# **Process Chilled Water for HEERC**

**Adam Anderson  
30 November 2023**

# Summary of HEERC Process Chilled Water

# Filtration Plan

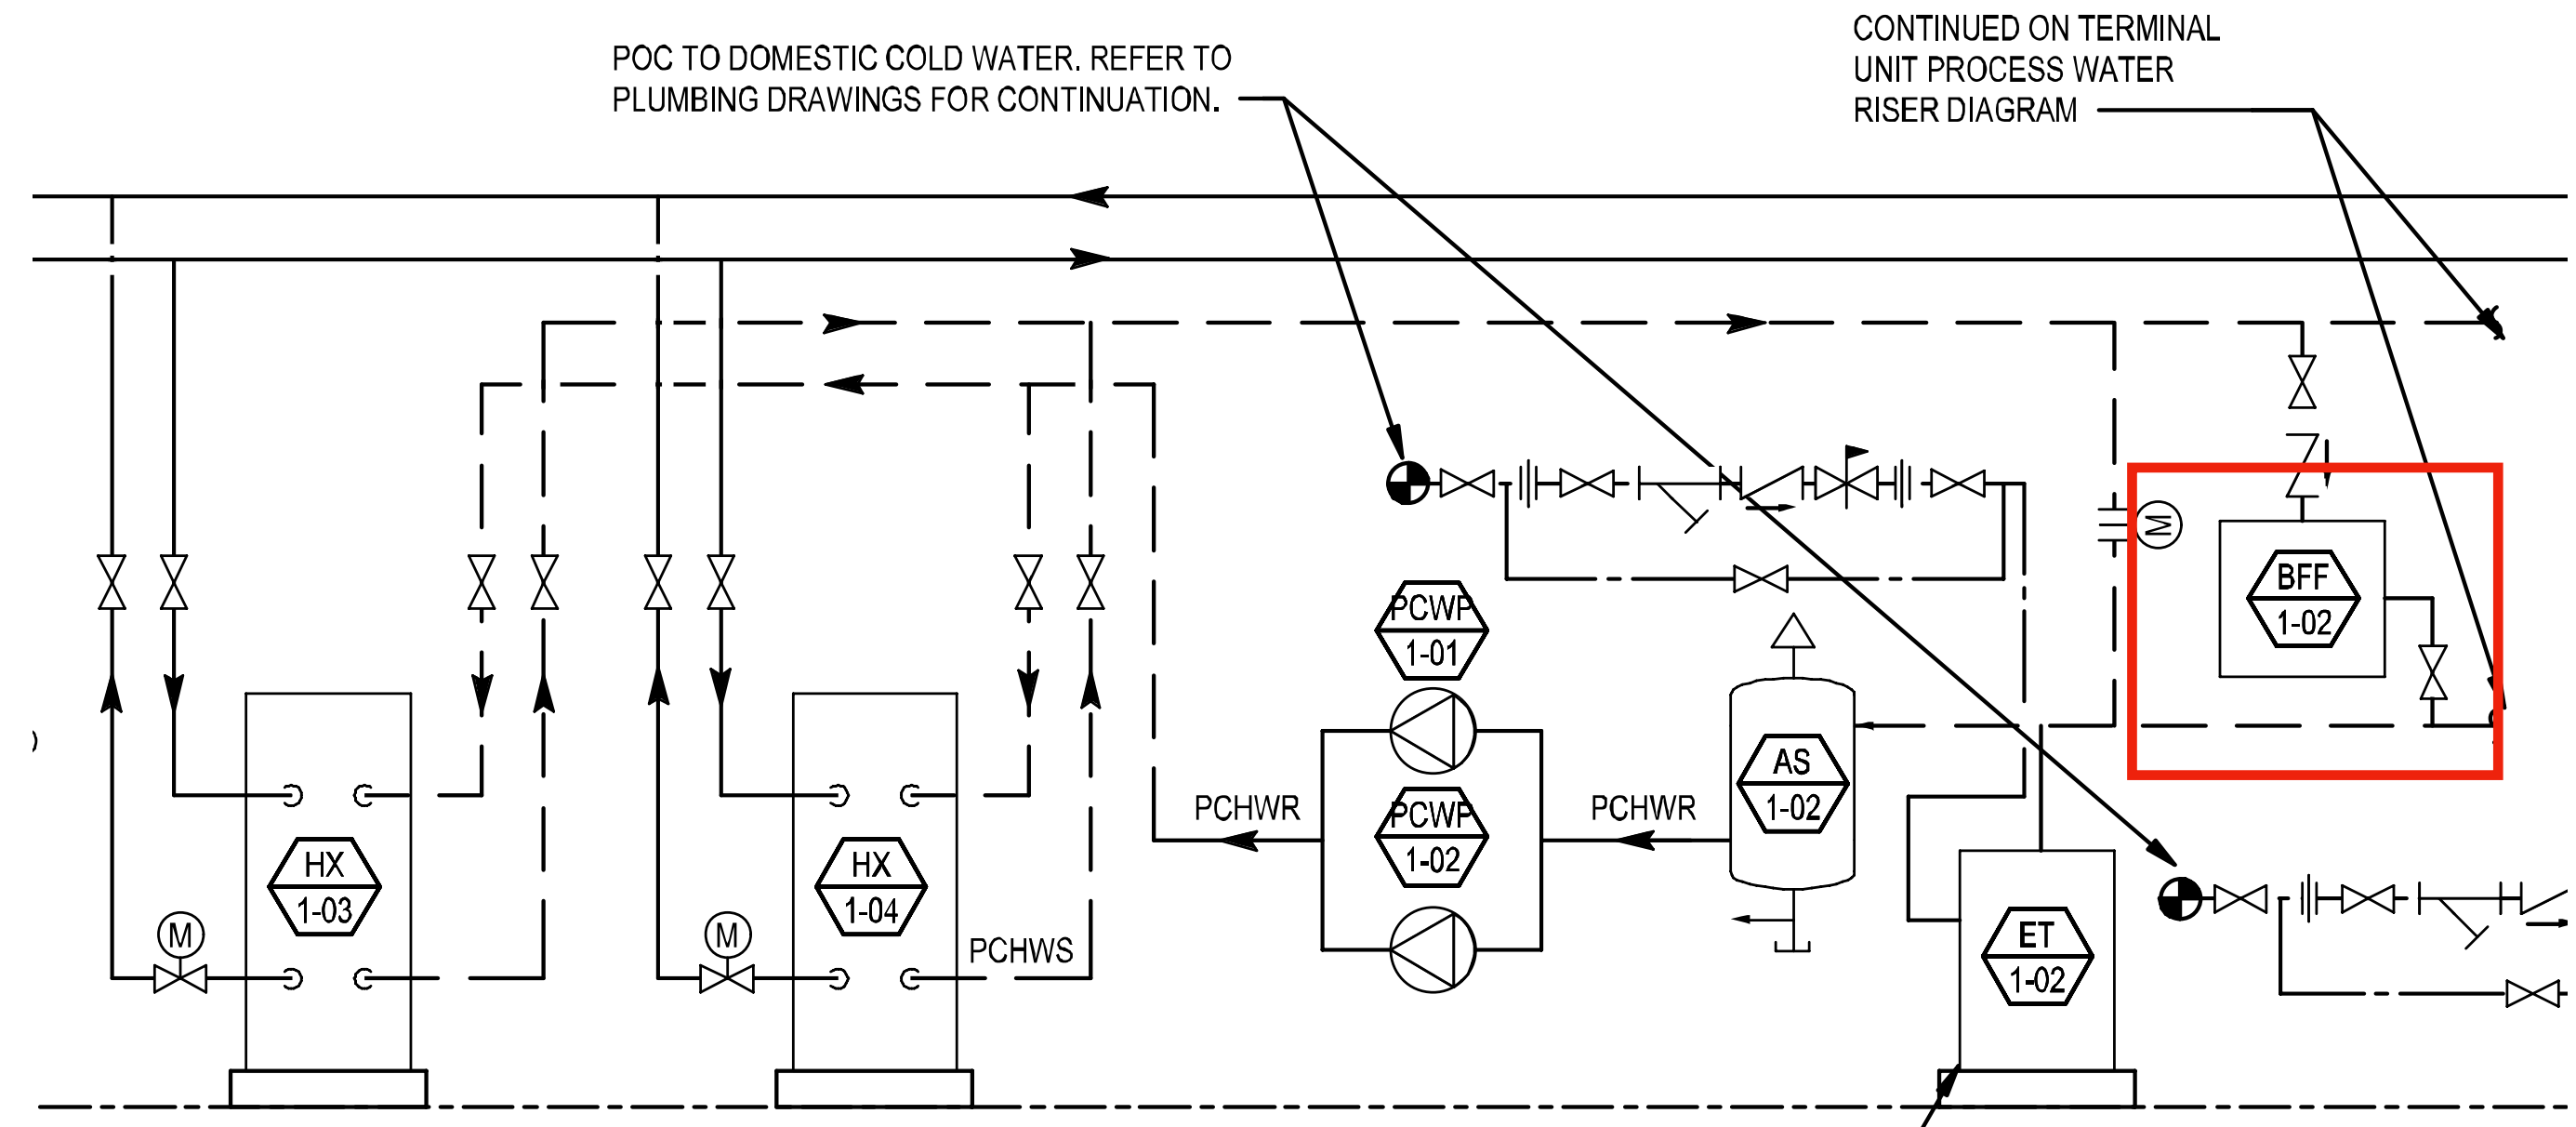
- Larry Hammond noticed that the existing bypass feeder for the heat exchanger has an optional filter conversion kit; thus, we simply need to perform this conversion to add filtration to the loop. See [datasheet](#) for filter kit.

- Points from Larry:
  - The BFF has isolation valves but doesn't have a balancing flow control valve. To be able to meter the flow through the filter to say 5-10% of the total flow a circuit setter type balancing valve should be added. Installing a pressure gauge on both sides of the filter is also recommending.

- With a task code from the users, the addition of the flow control valve and gauges could be done by ISD/FM.
- Still waiting on a more expert cost/labor estimate, but my rough guess is that the filter kit, valves, and gauges seem like maybe a few \$k + less than 1 day of labor to install.
